**DEVIATION REVIEW
 AND DECISION FORM**

**Deviation No. 1
 REV 2-8-19**

Subdivision or Project Name: Rollin' Ridge

Section of ECM from Which Deviation is Sought: 2.3.2 Design Standards by Functional Classification

Figure 4

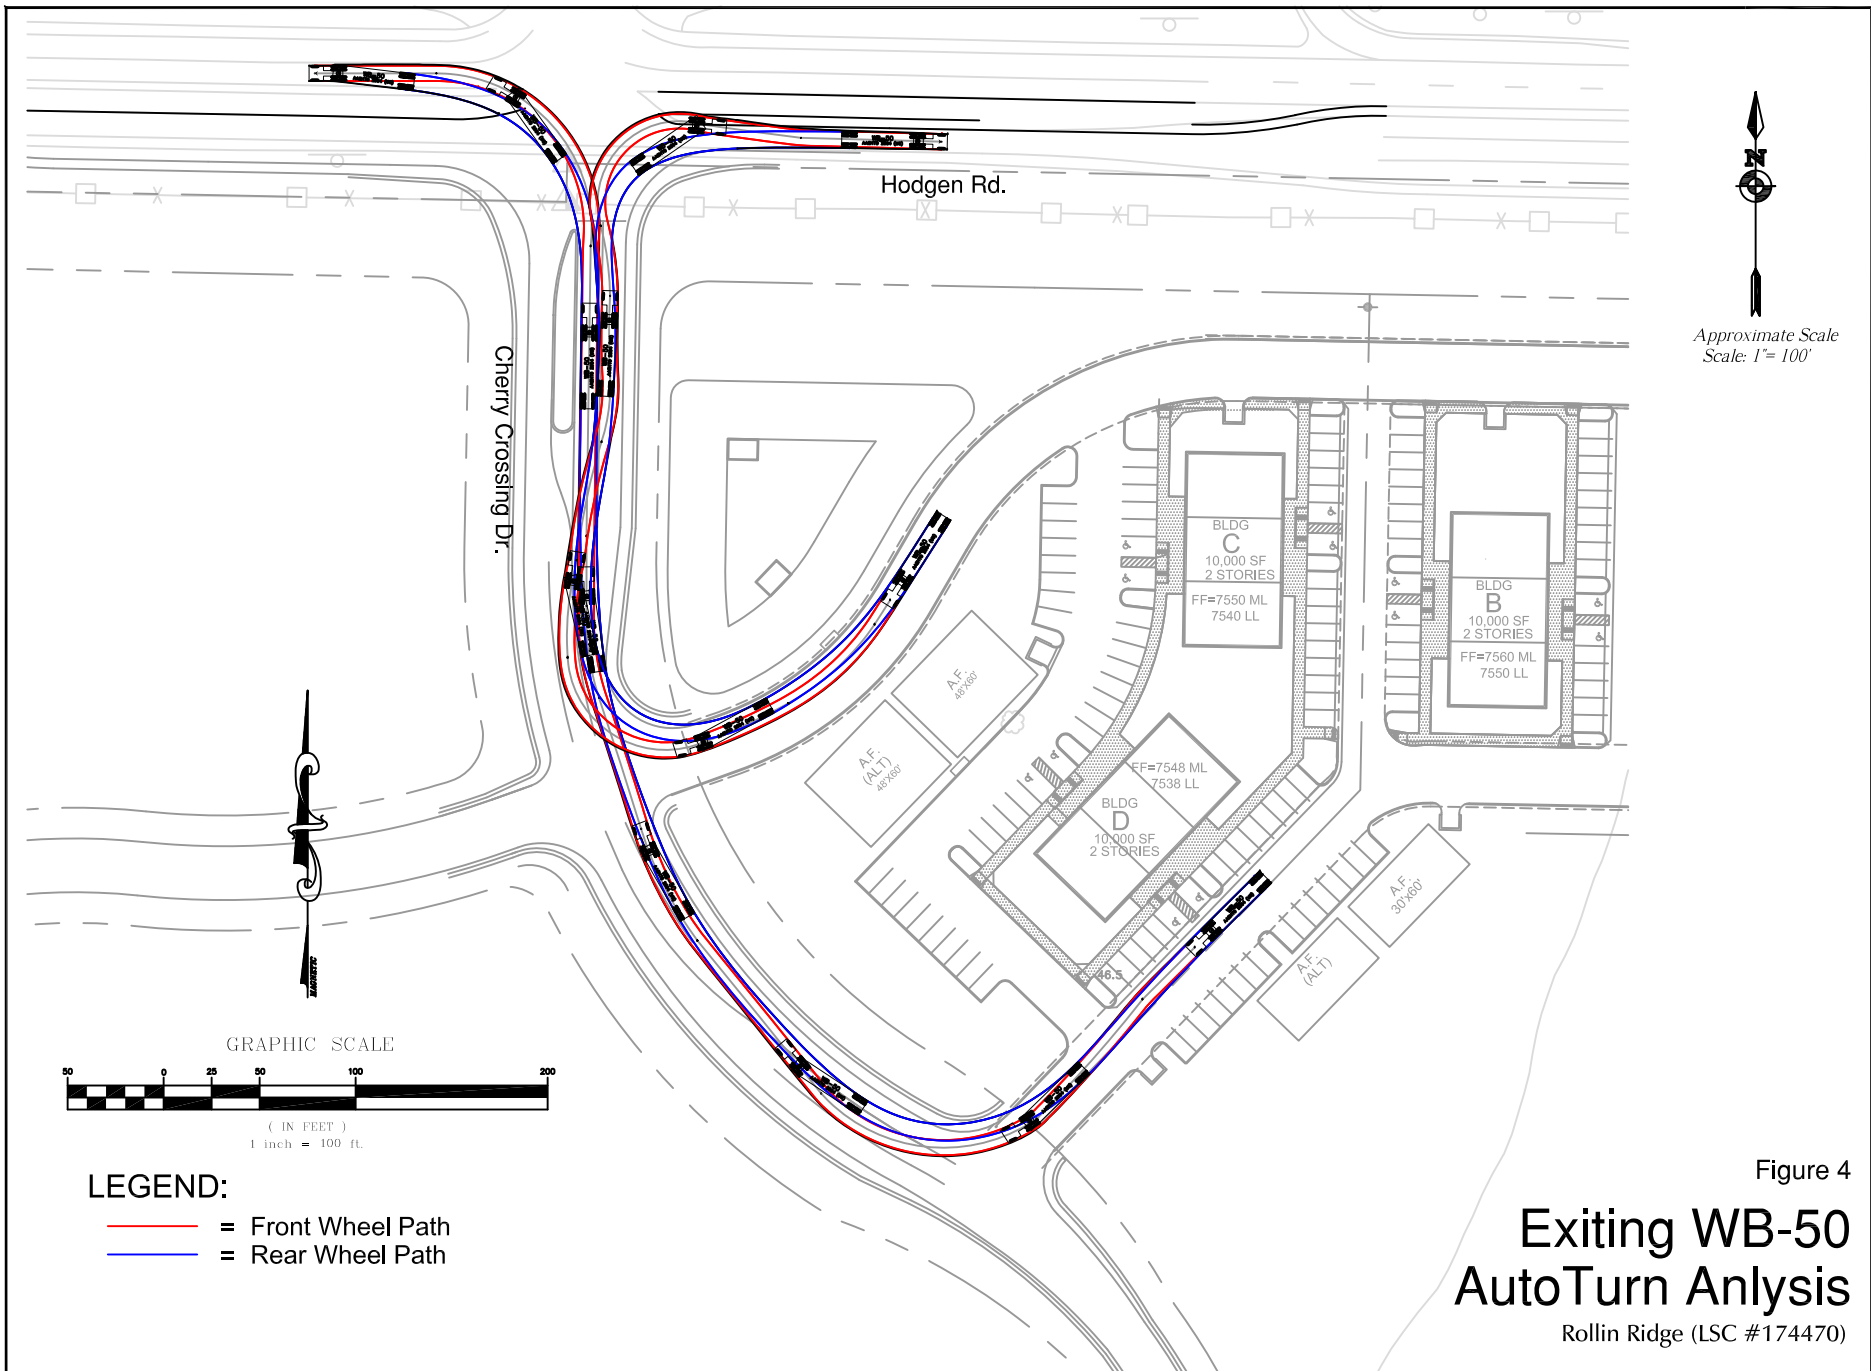
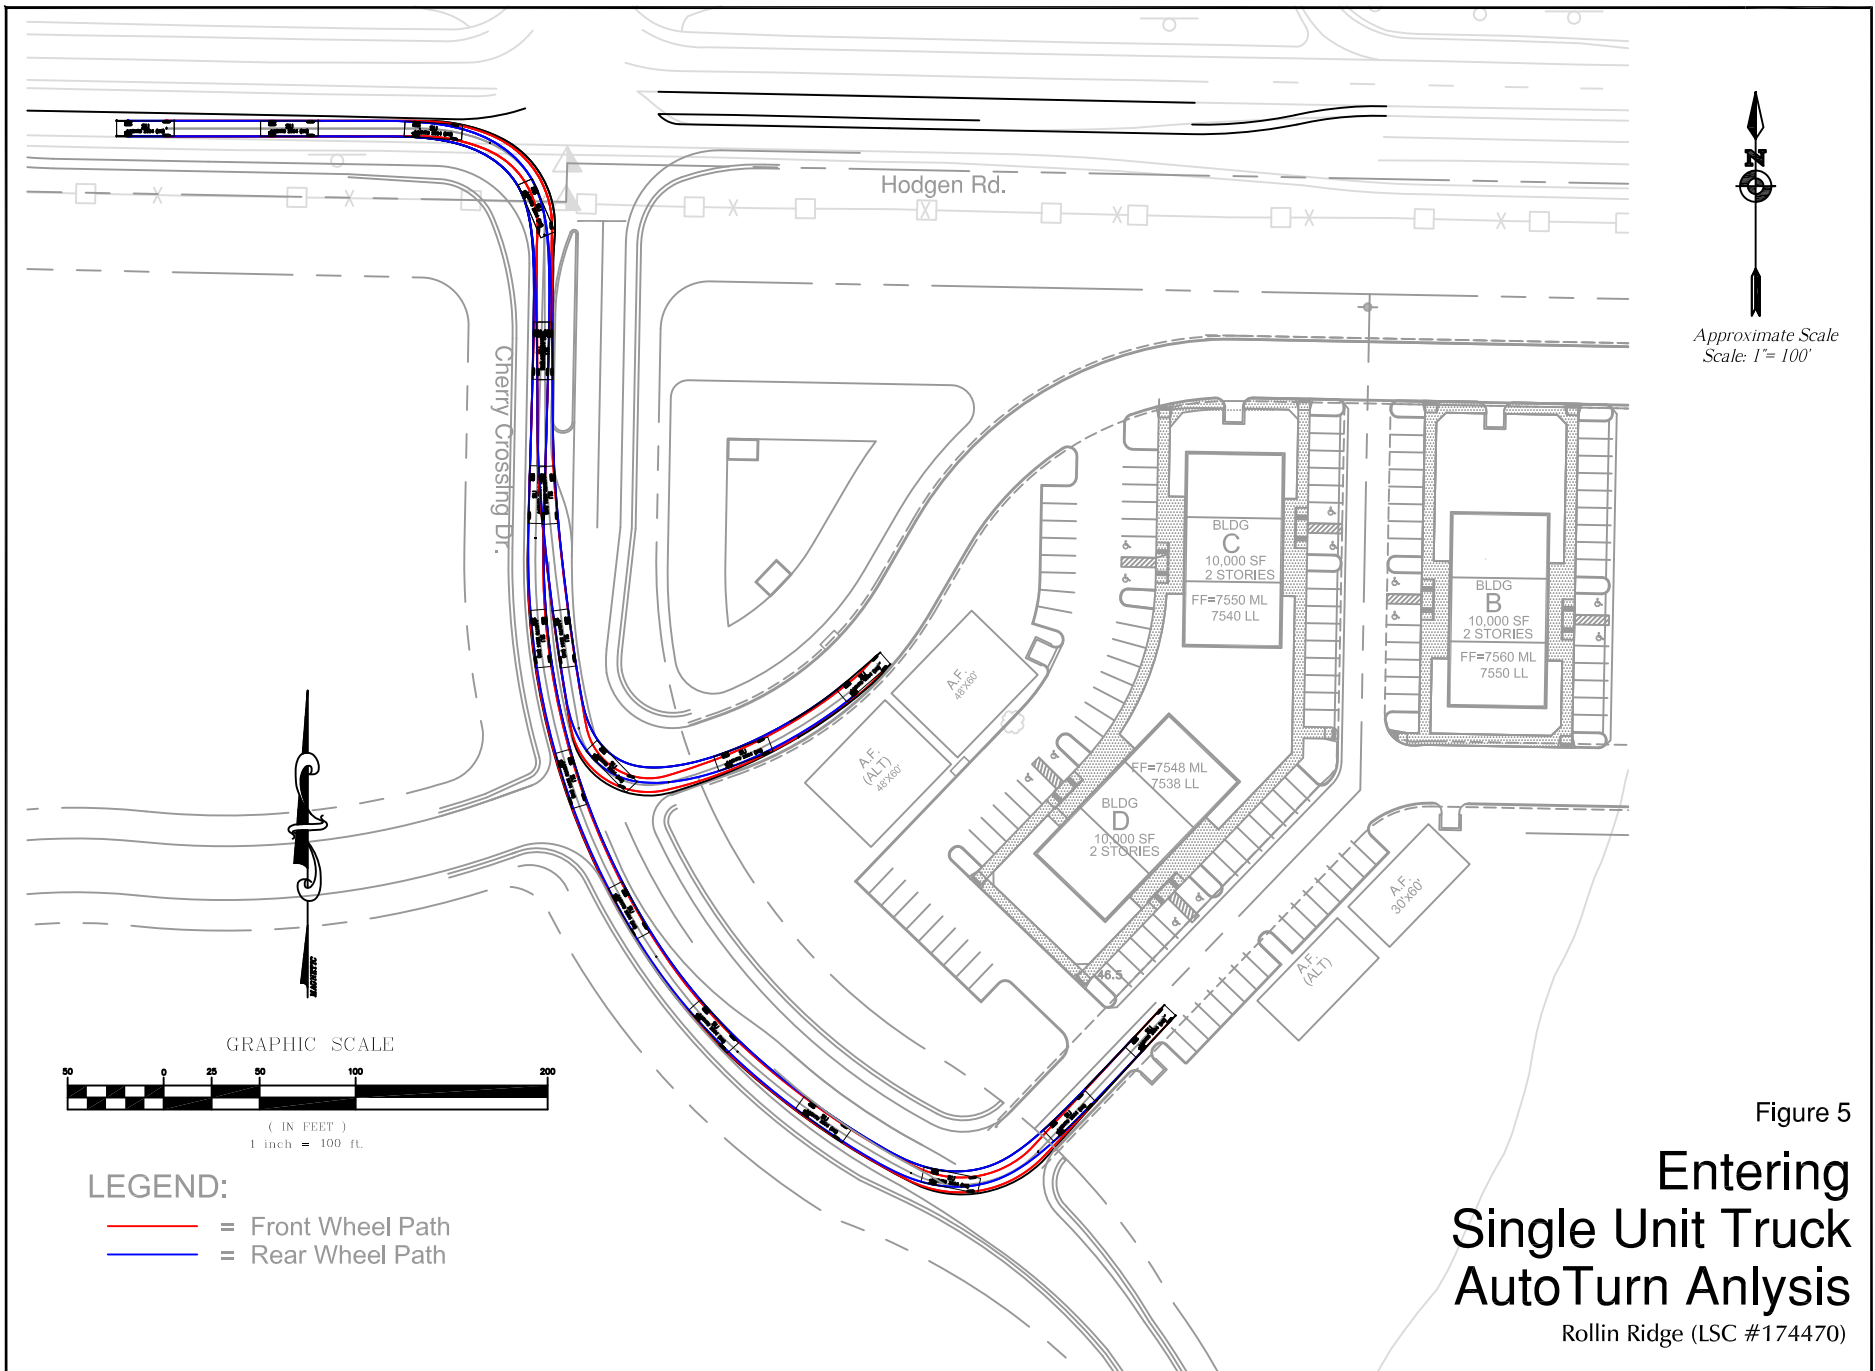
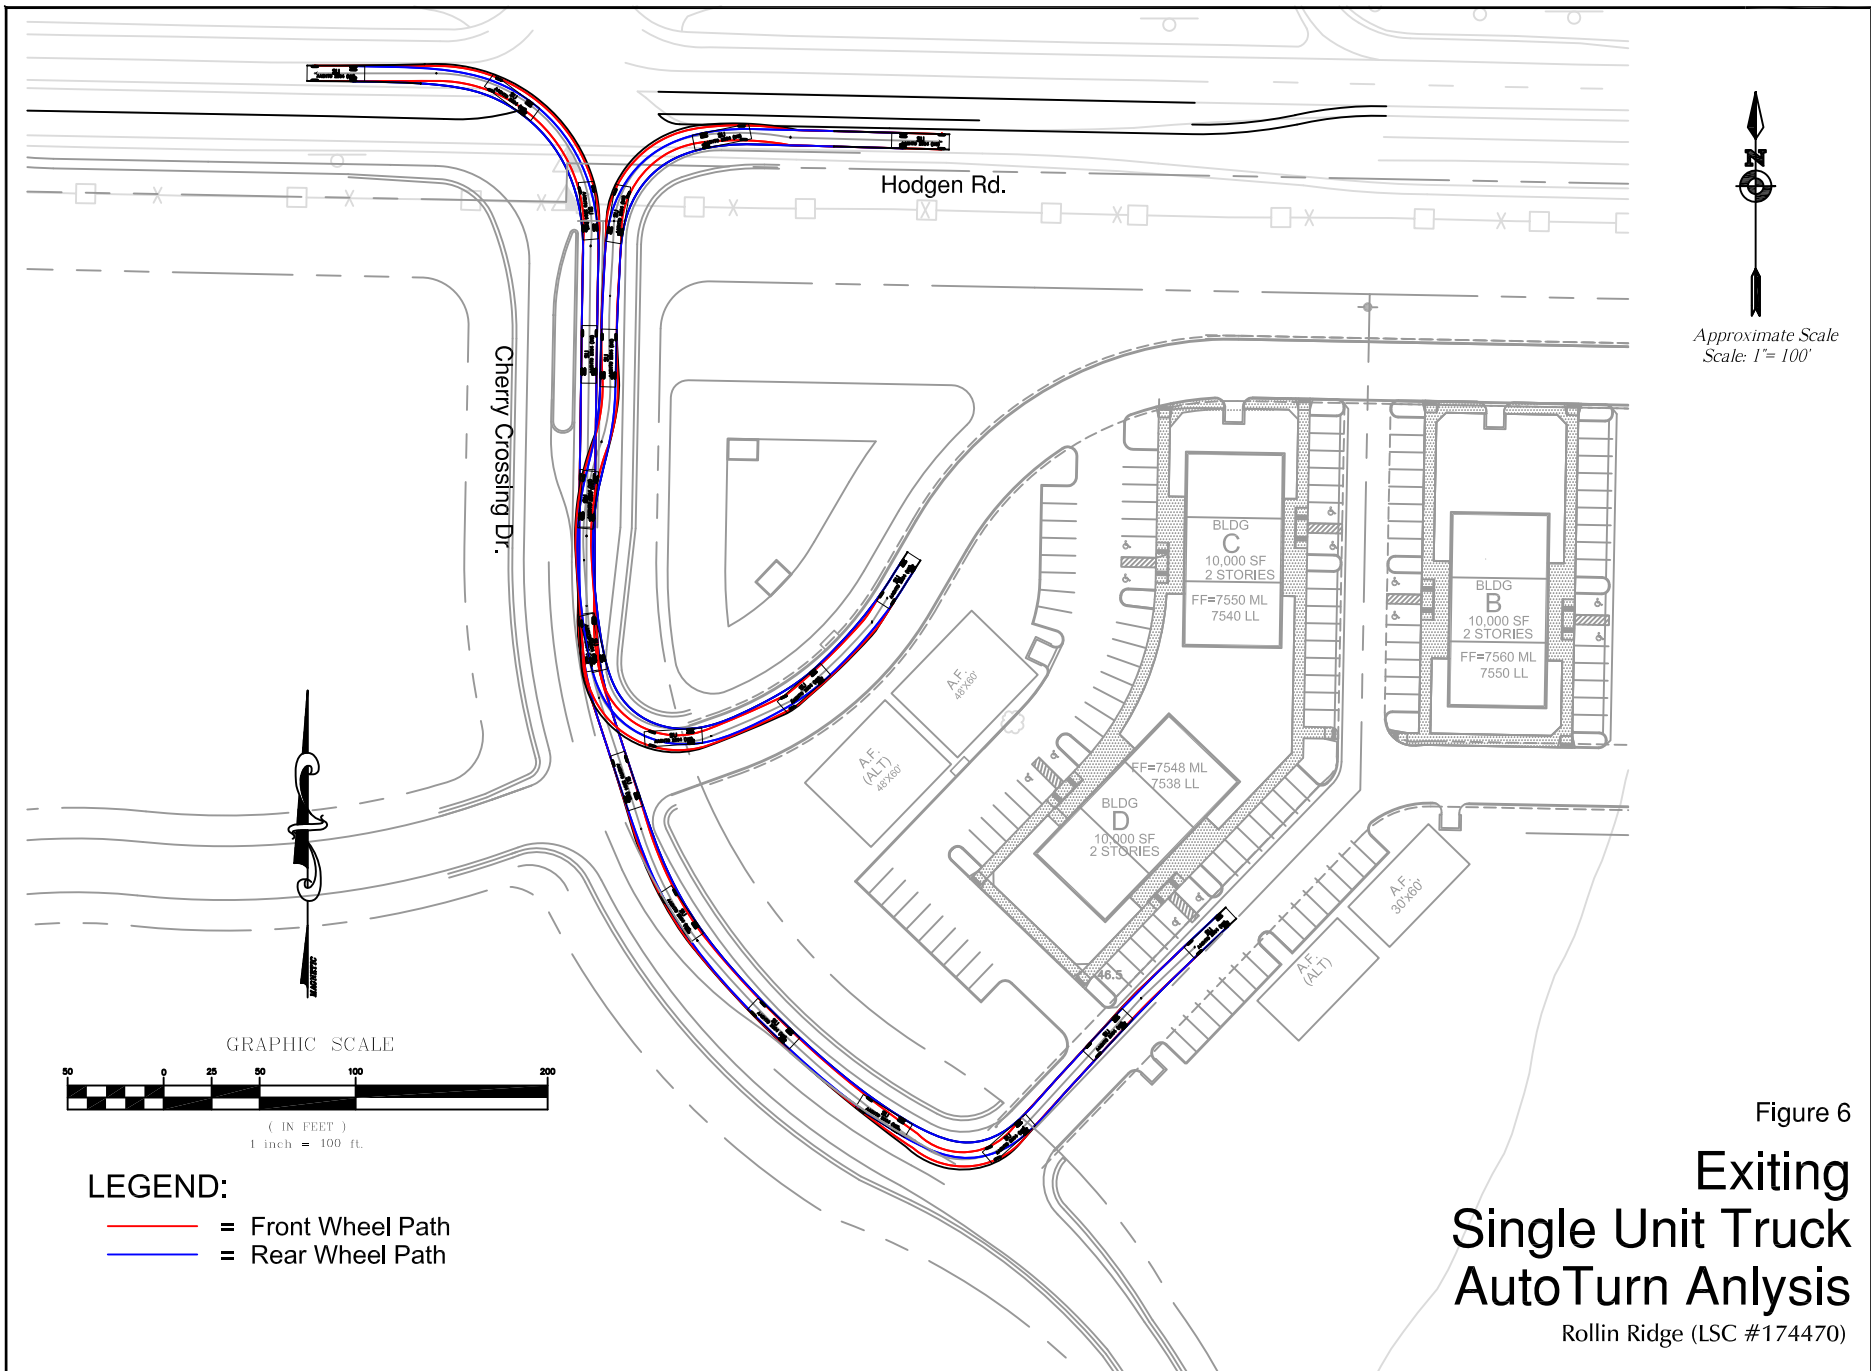
remove reference to intersection spacing, it is in deviation 2.
 This should be the only deviation with the turning movement exhibit (because of the narrower shoulder).
 Lane width should be discussed for clarification.
 Ditto comment on exhibits as stated in deviation 2.
 A

remove reference to intersection spacing, it is in deviation 2.
This should be the only deviation with the turning movement exhibit (because of the narrower shoulder).
